BC BUILDING CODE INTERPRETATION COMMITTEE
AIBC, APEGBC, BOABC, POABC

File No: 06-0053

INTERPRETATION

Subject: *firewall* between buildings having different roof elevations

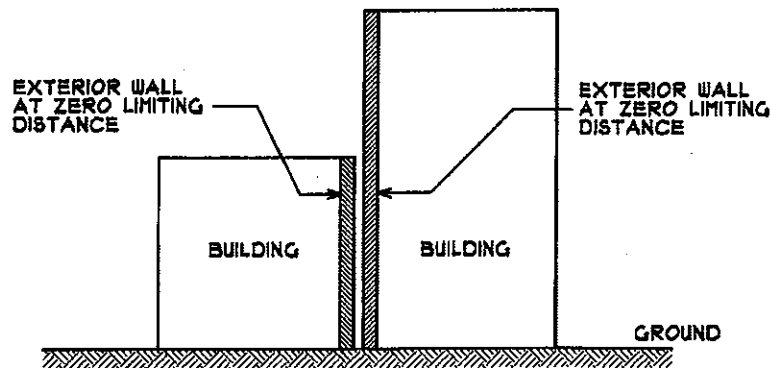
In the case of 2 separate walls being used to comprise the *firewall*, both walls are required to extend to the higher of the 2 roof elevations. It is noted that the effect of this requirement could be structurally challenging to achieve, particularly if the *firewall* is not of concrete or masonry construction, as Sentence 3.1.10.2.(4) permits.

An alternative approach to using a *firewall* to separate a building into 2 buildings is to design the 2 buildings facing each other with exterior walls at zero limiting distance such that the 2 exterior walls are each constructed under Article 3.2.3.7. In this case each respective wall is only required to terminate at the roof elevation of the building to which it is structurally attached.

Note that whereas *firewalls* are required to be provided with roof parapets in accordance with Article 3.1.10.4., Article 3.2.3.7 does not require roof parapets.

3.1.10.1.(2) & 3.1.10.3.(1)

3.2.3.7.(1) & (4)
